Access Compliance Report

Public Rights-of-Way

(Pedestrian Signals)

Intersection ID: N/A	Main Street:	Cross Street: N/A	Location: N/A
ADA ID: A67AA2D584C2	Signal Type: One Push Button-APS	Overall Compliance: No	Severity Score: BTN 1: N/A BTN 2: N/A No BTN: N/A
Codes/Mitigation Info/Possible Solution		Field Measurements/Component Compliance

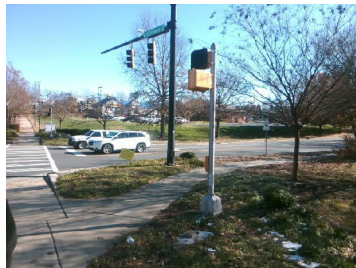
PROW/ADA: R209.1, TMUTCD 4e.08, R404.3, R404.2, R404.7.1, R404.7.2, MUTCD 4e.10

Yes	B 1 Clear Xing Direction?	ClearlyMarked	N/A	B 2 Clear Xing Direction?	N/A
	B 1 Crossing Direction	To N		B 2 Crossing Direction	N/A
Yes	B 1 DistanceTo XWalk (in)	0.0	N/A	B 2 DistanceTo XWalk (in)	N/A
No	B 1 DistanceTo Curb (in)	283.0	N/A	B 2 DistanceTo Curb (in)	N/A
Yes	B 1 Diameter (in)	2.0	N/A	B 2 Diameter (in)	N/A

Possible Solutions: Replace Signal Push Button With APS Button on New Post. Remove & Relocate Sign.
